ACCESSION NBR: 8409140165 DOC. DATE: 84/09/13 NOTARIZED: YES DOCKET #
 FACIL: 50-410 Nine Mile Point Nuclear Station, Unit 2, Niagara Moho 05000410
 AUTH. NAME: MANGAN, C.V. AUTHOR AFFILIATION: Niagara Mohawk Power Corp.
 RECIP. NAME: SCHWENCER, A. RECIPIENT AFFILIATION: Licensing Branch 2

SUBJECT: Forwards responses to SER Open Items 421.3, 4, 10, 13, 15, 18, 20, 23, 25, 27, 28, 34, 36, 37, 42, 43, 44 & 47, to aid in NRC review of application for license. Info will be included in next FSAR amend.

QUESTION F421.3 (7.1, 7.2, 7.3, 7.4, 7.5, 7.6) 1.10

FIGURE 421.13-1

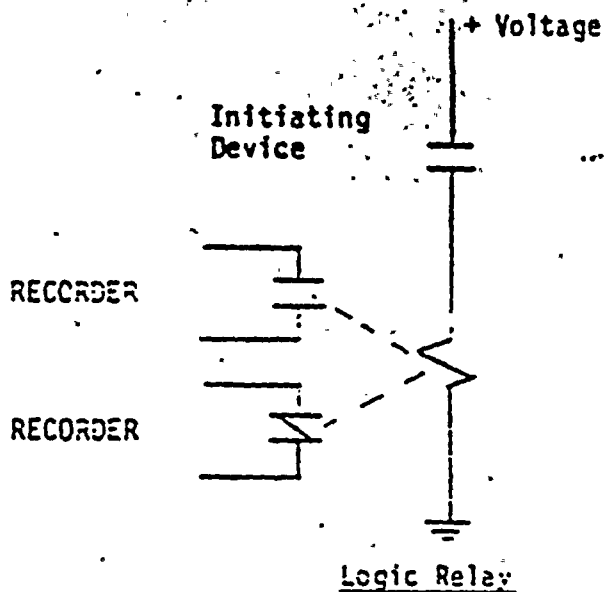
421.13 Various instrumentation and control system circuits in the plant
(7.1) rely on certain devices to provide electrical isolation capability
(7.2) in order to maintain the independence between redundant safety-
(7.3) related circuits and between safety-related circuits and nonsafety-
(7.4) related circuits. Provide the following information:
(7.5)
(7.6)

f. Typical Test Set-Up (see Figure 421.13-1)
